Access Compliance Report

Public Rights-of-Way

Intersection ID: N/A	Main Street: LANGWELL_LN	Cross Street: INVERNESS_BAY_RD	Location: SW
ADA ID: 6549B298BDCD	Ramp Type: Perp	Initial Pass/Fail: Fail	Overall Compliance: No
Severity Score: 33.75			
Codes/Mitigation Info/Possible Solution		Field Measurements/Component Compliance

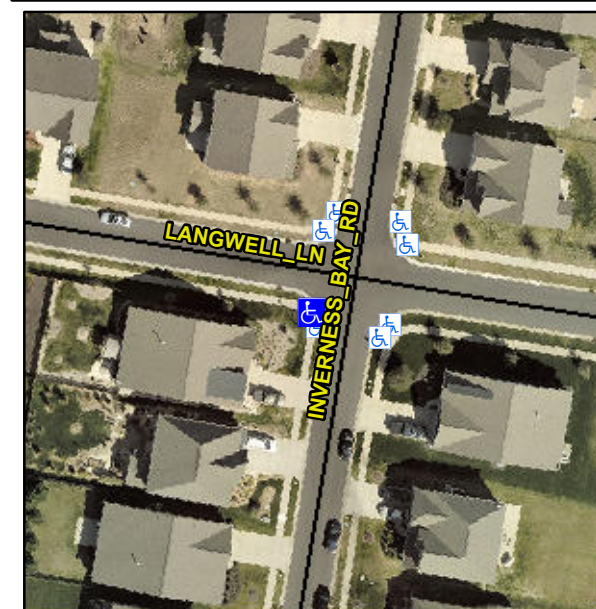
R304.5.1, R304.2.2, R304.5.3

Compliance	Description	Data	Compliance	Description	Data
N/A	Ramp Length (in)	48.5	No	Ramp Slope (%)	8.5
No	Ramp Width (in)	47.0	No	Ramp XSlope (%)	5.2
N/A	Flare Type LT	N/A	N/A	Flare Type RT	N/A
N/A	Flare Slope LT (%)	N/A	N/A	Flare Slope RT (%)	N/A
N/A	Flare Traversable LT?	N/A	N/A	Flare Traversable RT?	N/A
N/A	Landing Length (in)	N/A	N/A	DWS Provided?	N/A
N/A	Landing Width (in)	N/A	N/A	DWS Contrast?	N/A
N/A	Landing Slope (%)	N/A	N/A	DWS Length (in)	N/A
N/A	Landing X Slope (%)	N/A	N/A	DWS Full Width?	N/A
N/A	Landing Curb? (Y/N)	N/A	N/A	DWS Offset (in)	N/A
N/A	Shared Landing?	N/A			
N/A	Gutter Ponding?	N/A	N/A	Gutter Slope (%)	N/A
N/A	Gutter Lip Ht (in)	1.0	N/A	Gutter X Slope (%)	N/A
N/A	Painted X Walk1?	No	N/A	Painted X Walk2?	N/A
	X Walk 1 Direction	To NE		X Walk 2 Direction	N/A
N/A	X Walk 1 Width (in)	N/A	N/A	X Walk 2 Width (in)	N/A
	X Walk 1 Slope (%)	2.2		X Walk 2 Slope (%)	N/A
	X Walk 1 X Slope (%)	1.3		X Walk 2 X Slope (%)	N/A

Remove & Replace Entire Ramp.
